Planning Commission

**January 12, 2012
City Hall, Council Chambers
749 Main Street
6:30 PM**

- **Resolution No. 29, Series 2011, Steel Ranch South (Takoda, Planning Area 4)** 11 MB, a preliminary subdivision plat and preliminary planned unit development for an approximate 17 acre parcel of the Takoda Subdivision with the intent to develop the property with a maximum of 306 residential units (220 – 240 apartments and 60 – 70 townhomes or duplexes). (Continued from the December 8, 2011 meeting)

DECEMBER 12, 2011 PLANNING COMMISSION MEETING

Multi-Modal Street Design

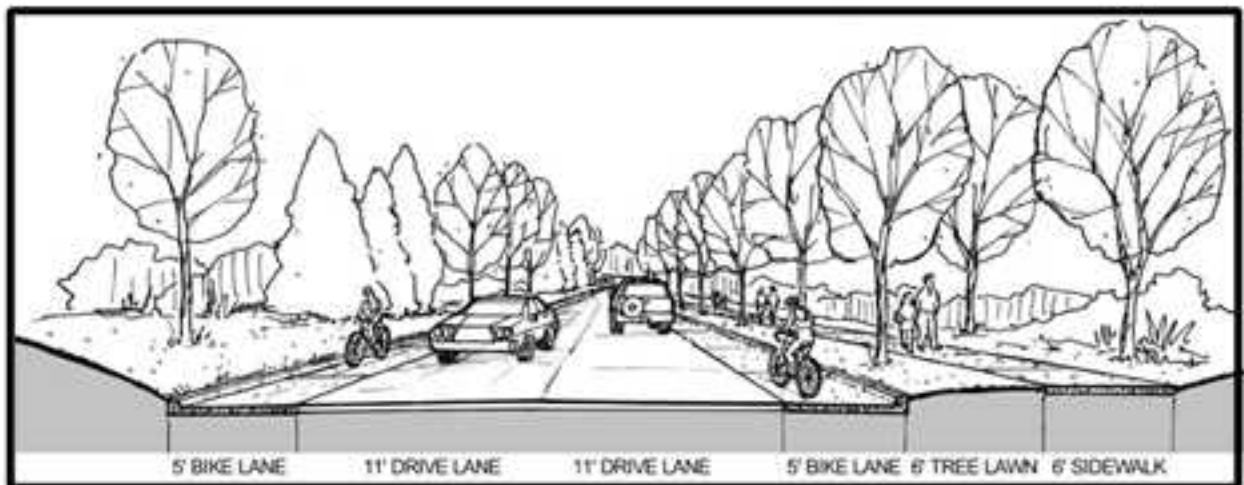
The City is willing to continue to work with the applicant to determine an acceptable alternative ROW and street design dimensions prior to final submittal.

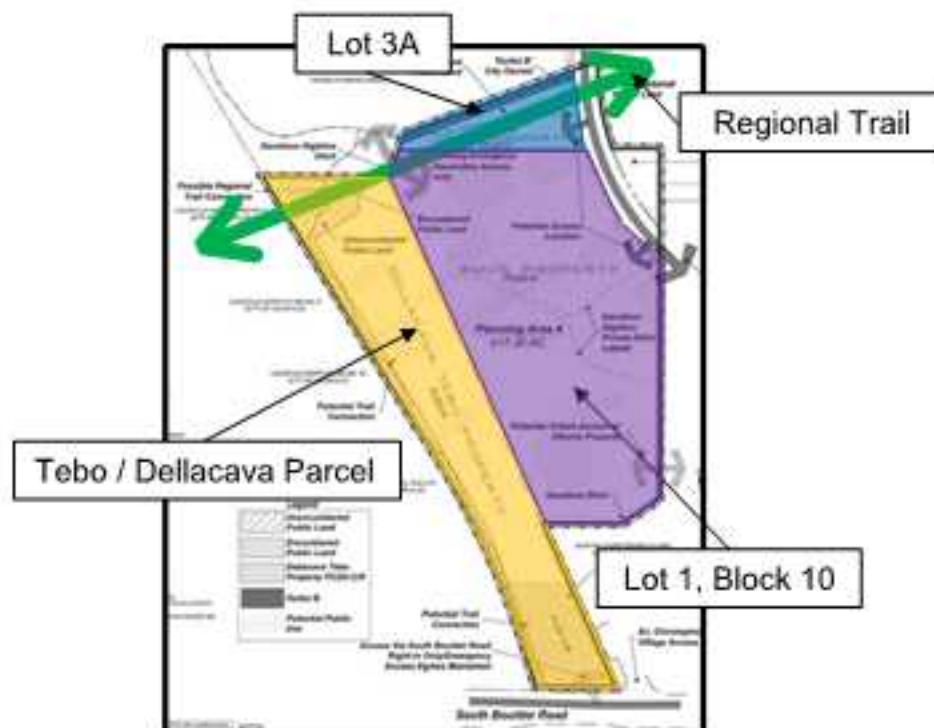
As proposed, the turning radius the intersection of Steel Street to Luke Street, along with ROW dimensions do not meet City Standards. The applicant and Public Works Department have determined a roundabout, or similar design, could be considered at

this location. City design standards do not address roundabouts; however, City staff is familiar with national best practices and are familiar their design requirements.

In concept staff supports the design of the roundabout, or similar solutions, along with a possibility of narrow street cross sections within residential areas for traffic calming purposes. Staff is willing to consider accepting nonstandard alternative designs to those proposed for Steel Street and Luke Street as public ROWs in the Final Plat and PUD submittal after further design specifics are vetted with the applicant and the Public Works Department.

Option #3

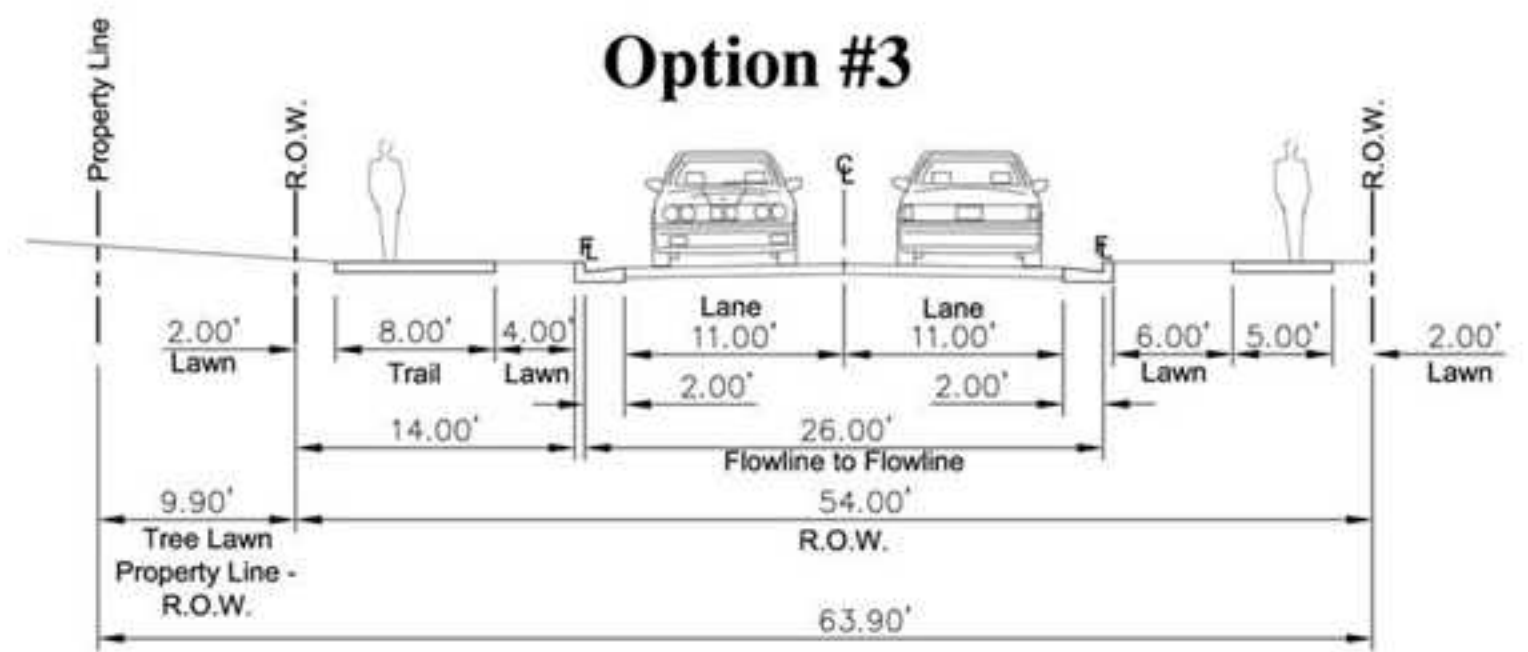
- c. Option #3 – The 26 foot flow line appears too narrow for Fire District to safely access and does not provide any additional right of way for snow storage. Staff acknowledges the option includes a detached trail on the west, however the proposed lawn on the east side is too narrow for sound buffering landscaping. The 9.9 foot tree lawn on the west side does provide adequate area for trees and shrubbery.
